A303 Amesbury to Berwick Down

TR010025

8.10.3 Air quality and emissions (AQ.1)

Air quality and emissions (AQ.1)

Drawing Title: **FIGURE 1.10A AIR QUALITY REGIONAL STUDY AREA OPENING YEAR**

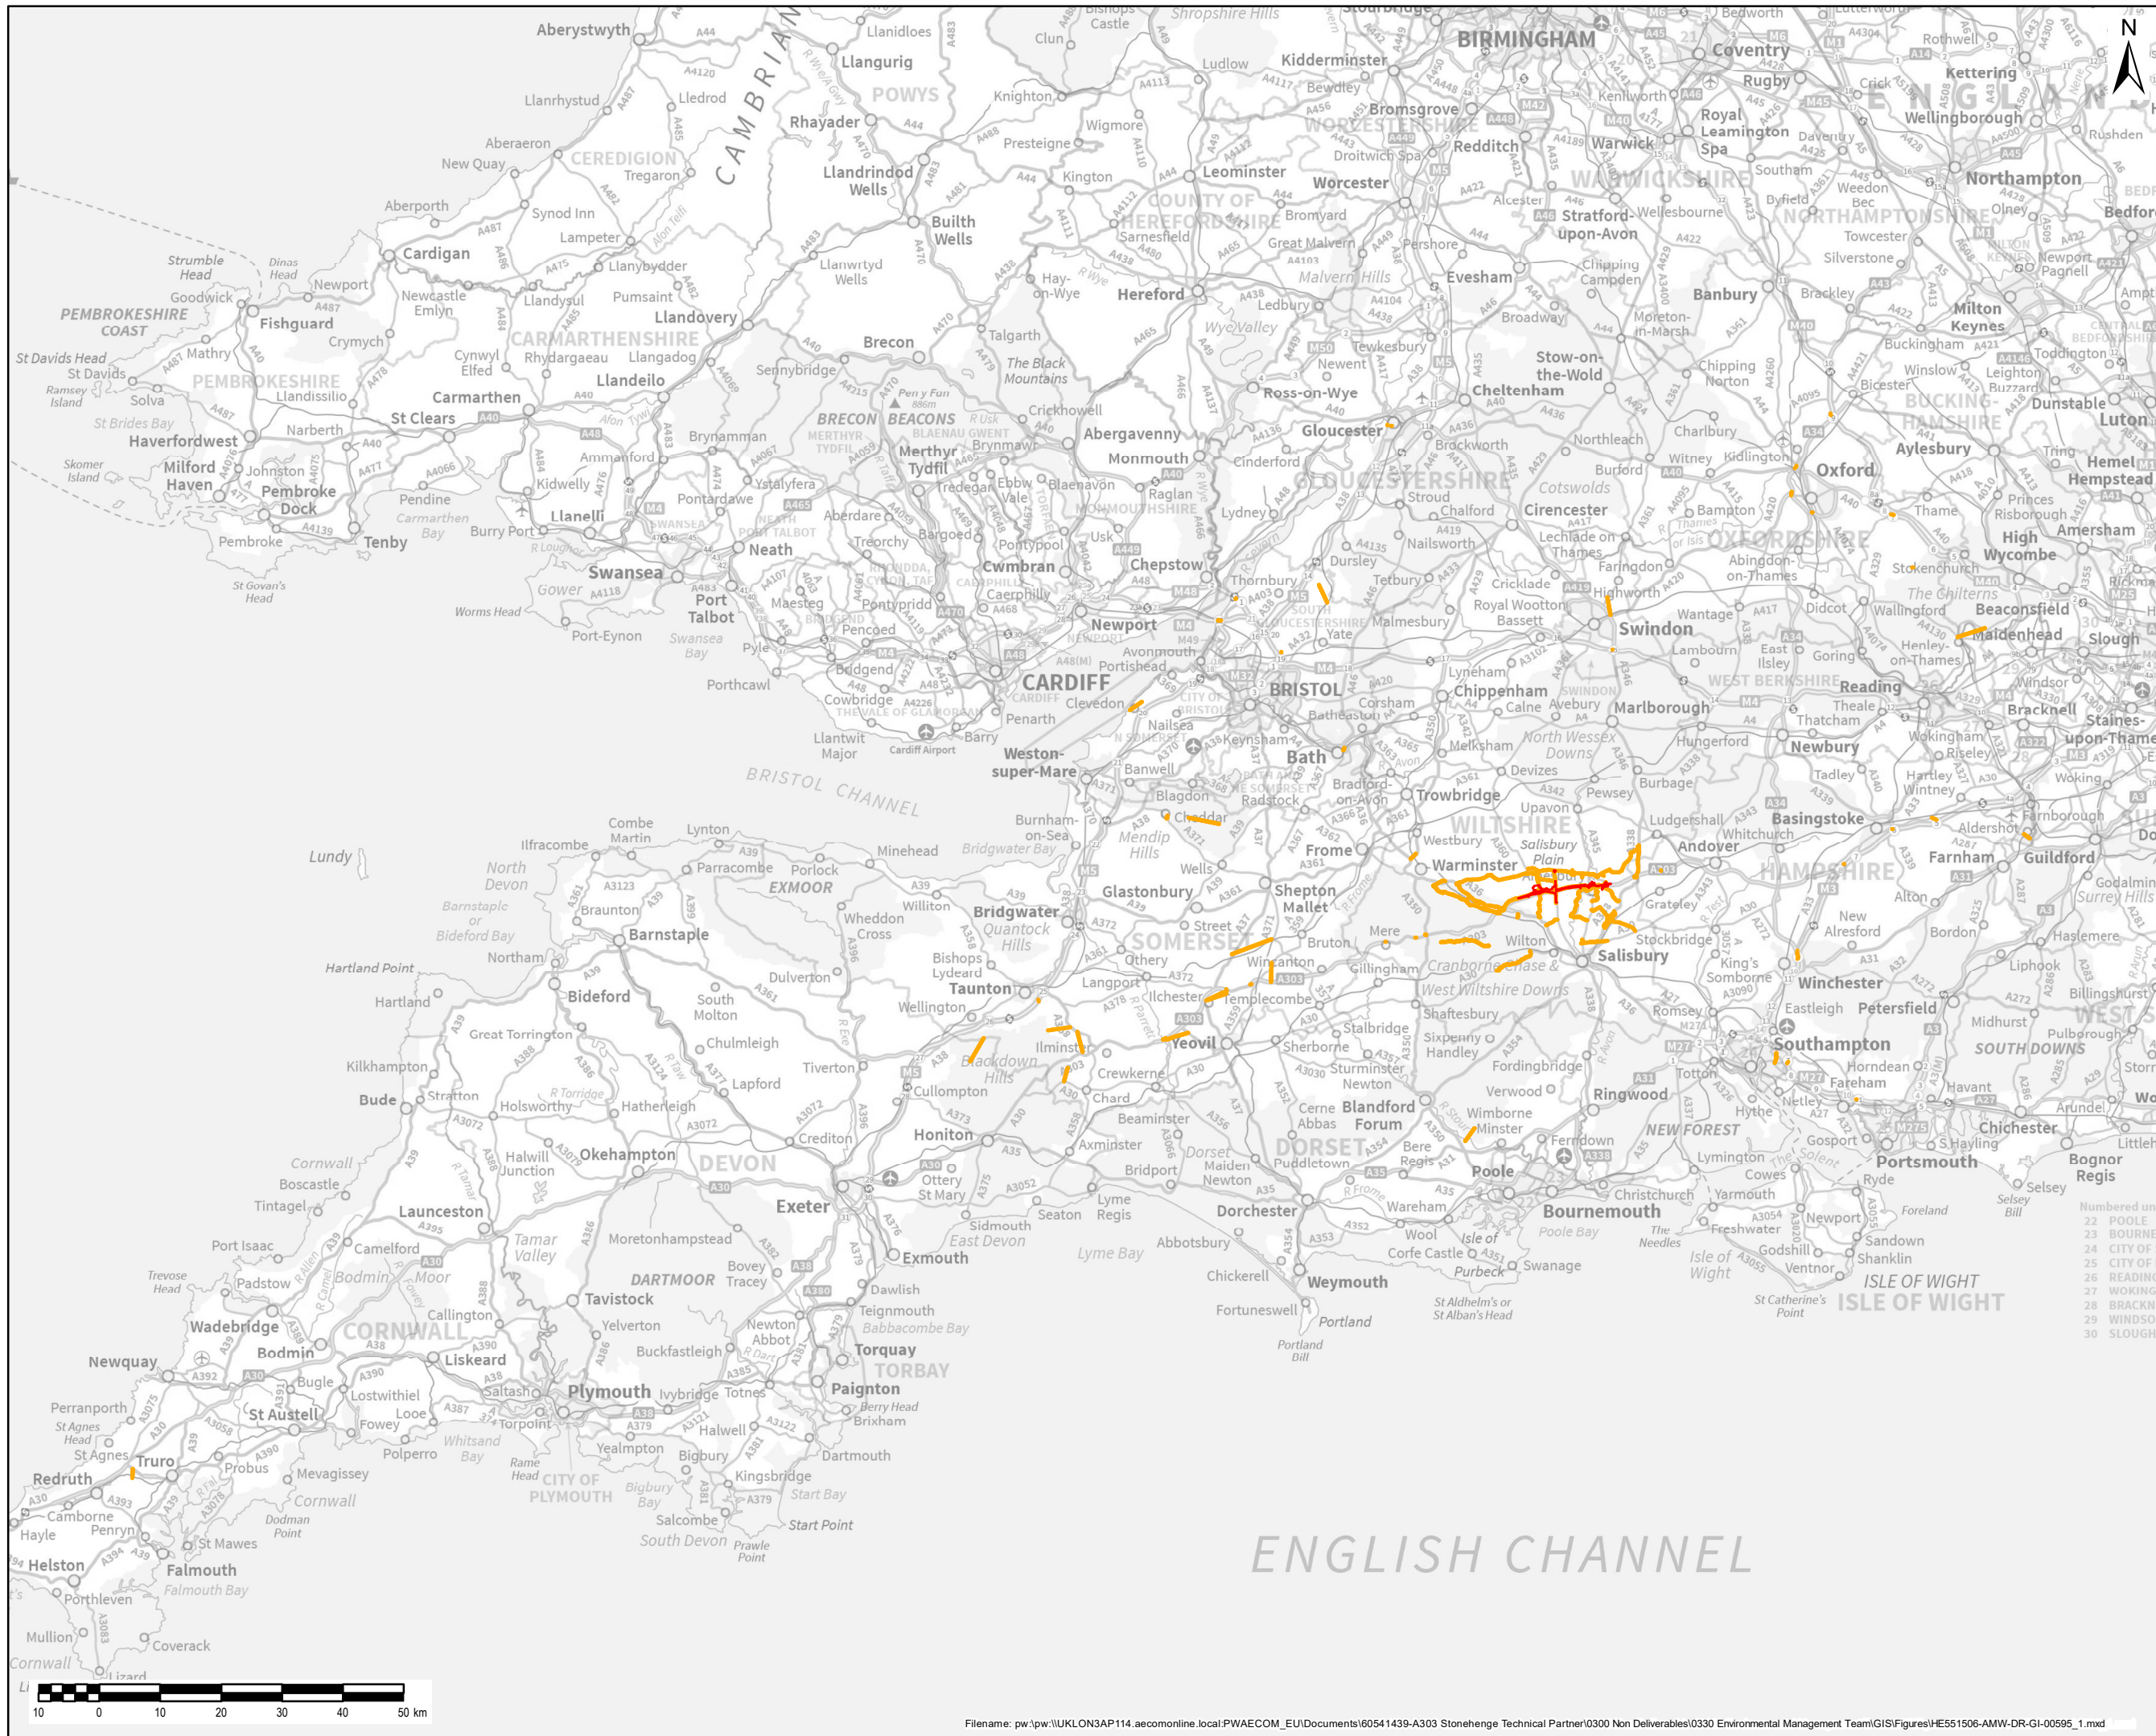
Can the Applicant provide a plan depicting the study area for the regional AQA?

5. Plans illustrating the study area for the regional air quality assessment have been provided as part of this response. Appendix Figures AQ1.10A and AQ1.10B depict the study area for the regional air quality assessment for the opening and design years respectively. The figures show roads with predicted qualifying changes in traffic data in line with the regional screening criteria set by DMRB air quality guidance. These roads are focussed within the area encompassing the Scheme and surrounding roads with some isolated links in the wider Region of Focus.
